ADDENDUM NO. 1

July 9, 2019

RE: ORANGE SOUTHWEST SCHOOL DISTRICT, RANDOLPH, VERMONT
RANDOLPH UNION HIGH SCHOOL LOADING DOCK AND PAVEMENT REDEVELOPMENT

PROPOSED
CONDITIONS PLAN

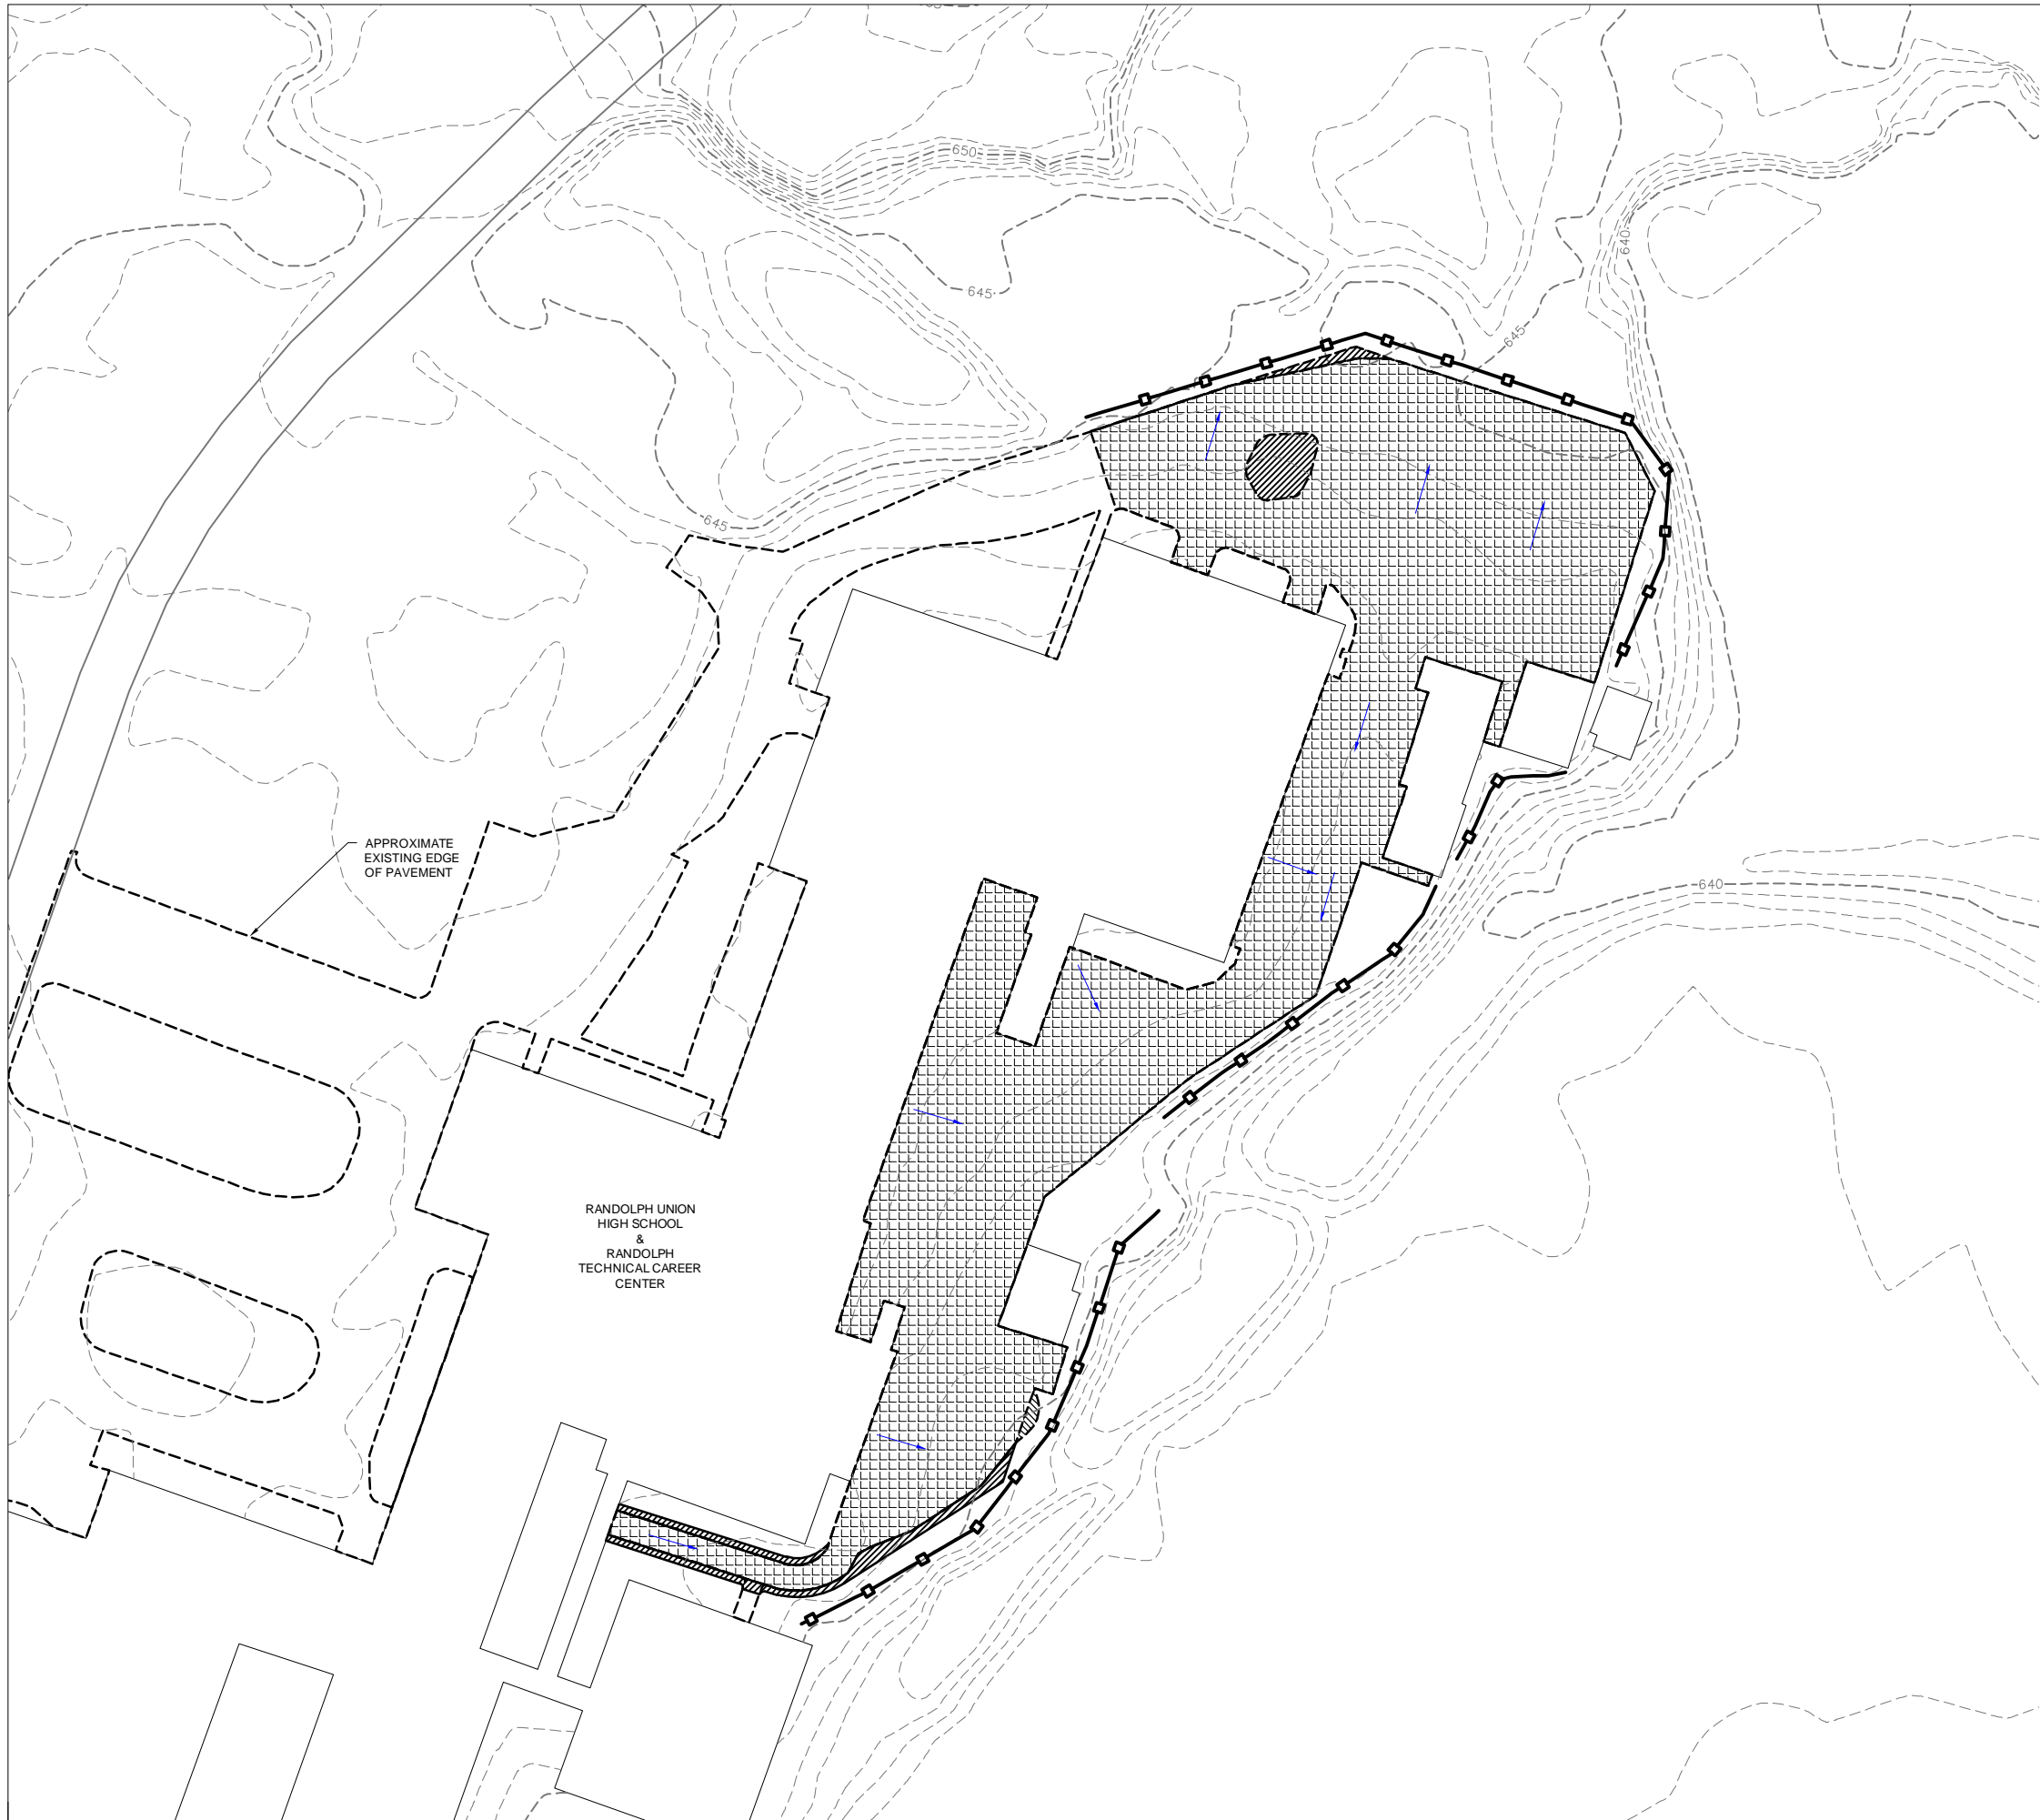
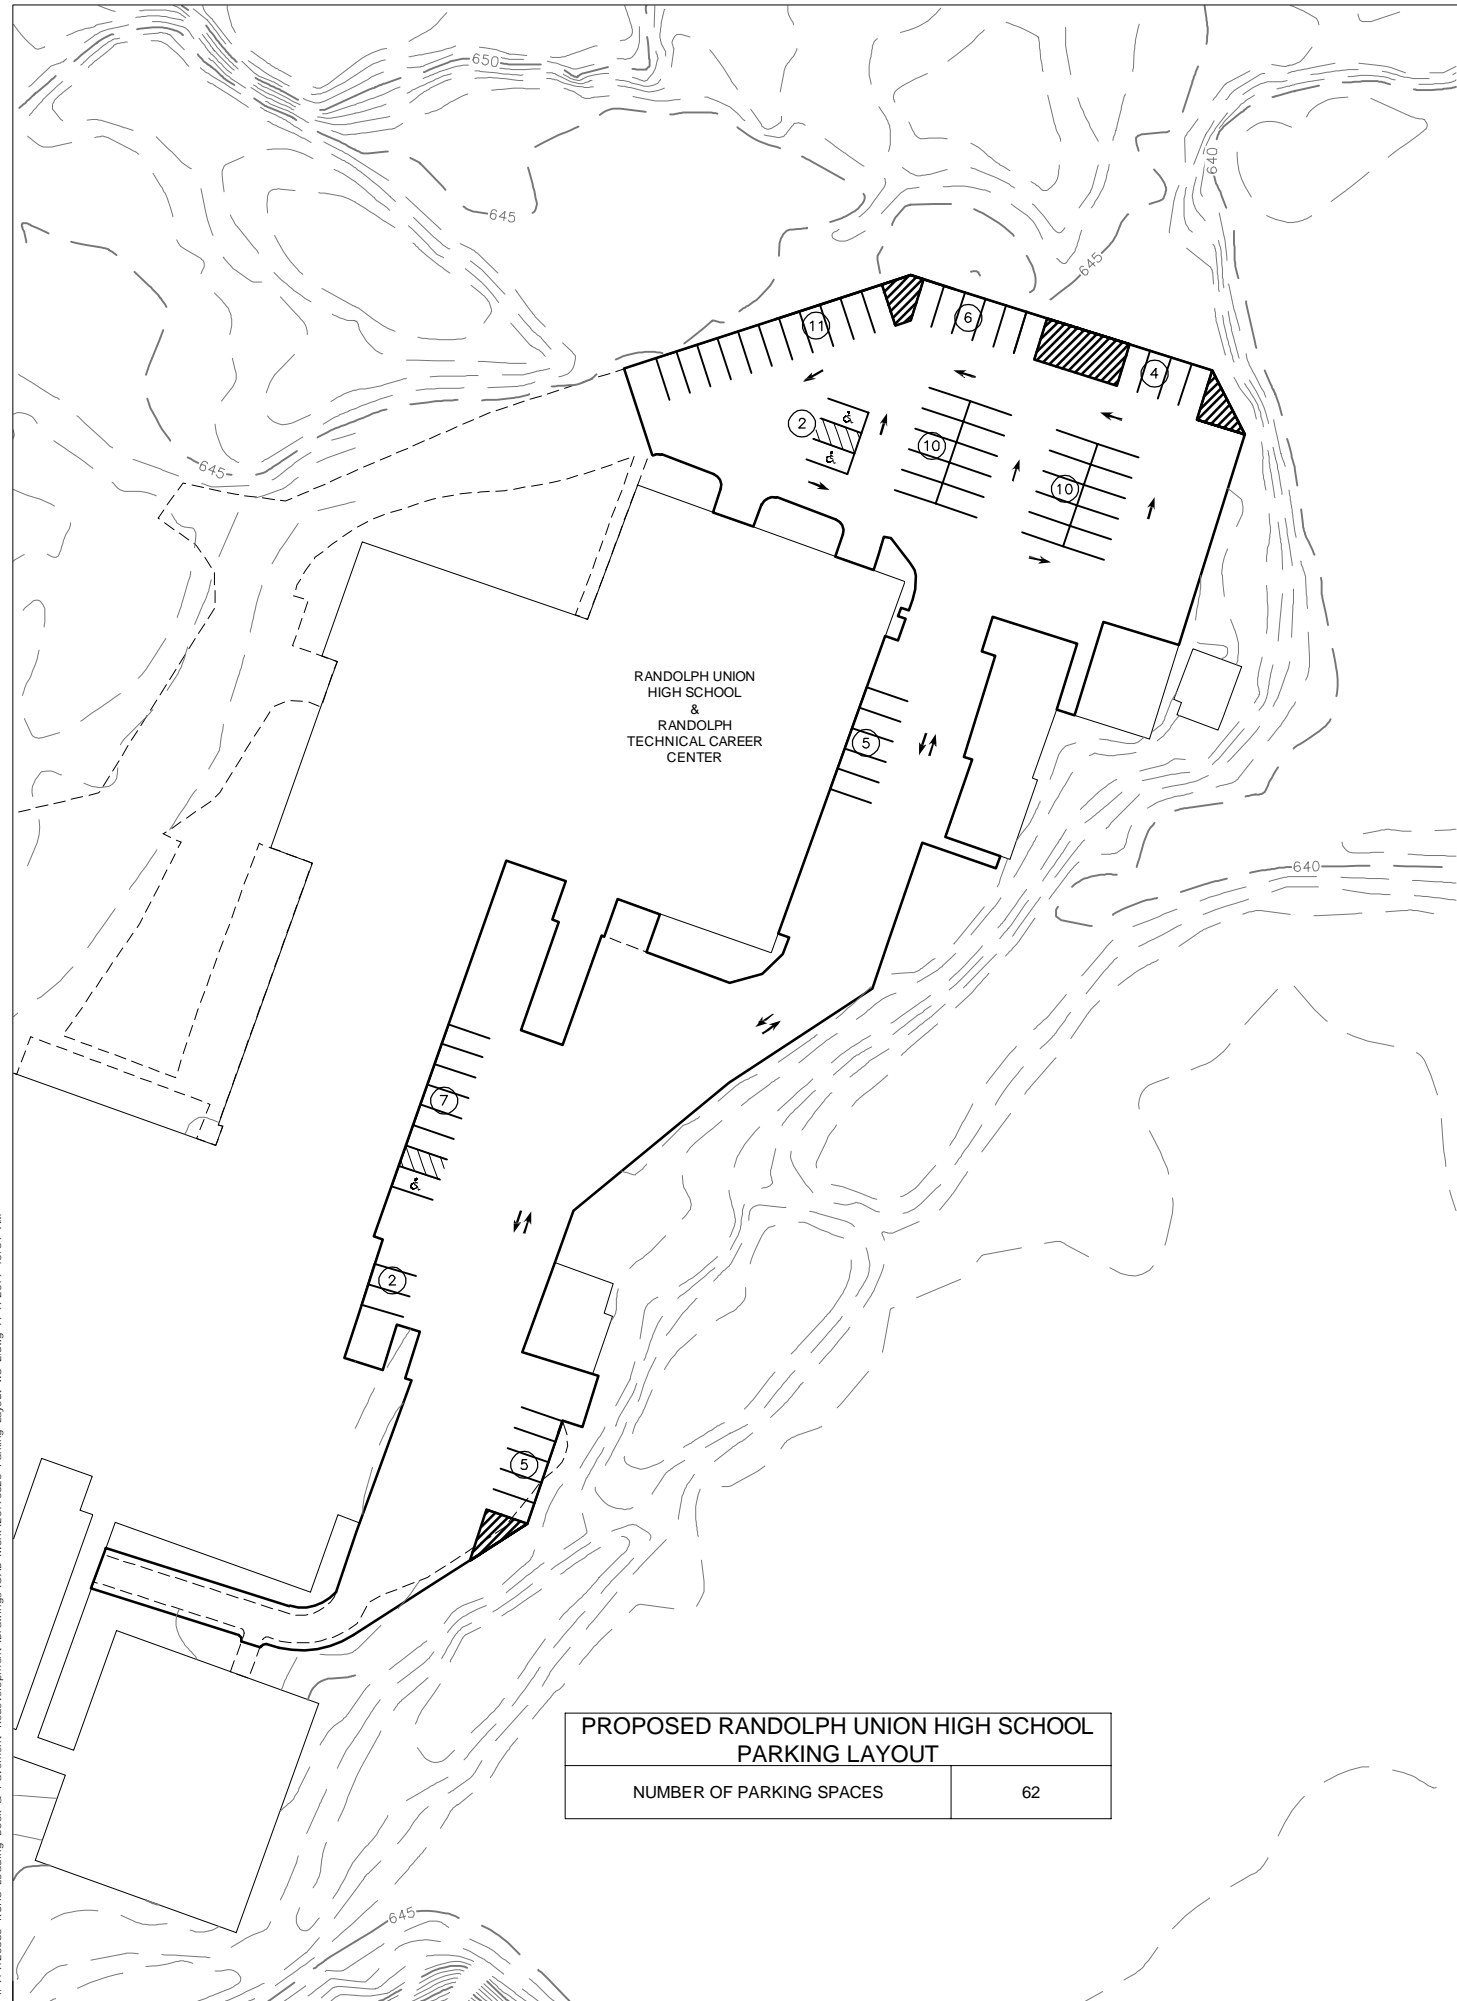
Attached is a revised Sheet C-2, Proposed Conditions Plan, to include an additional area of new pavement; and supersedes Sheet C-2 provided in the Bid Plan Set (Attachment B).

DIRECTIONAL ARROW
NOT TO SCALE

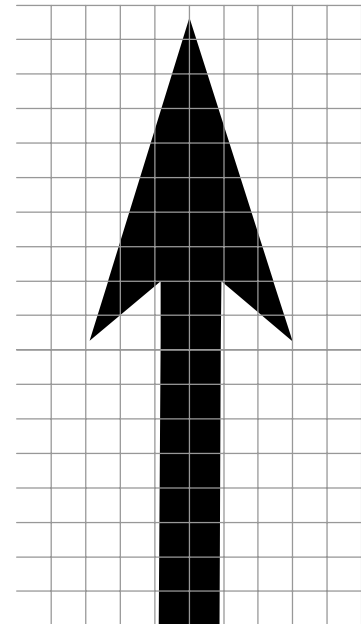
Question 4: Will the parking lot striping include centerlines or directional arrows?

Answer 4: Parking lot striping will include the installation of directional arrows on the pavement. A detail is provided on the attached Parking Layout Plan.
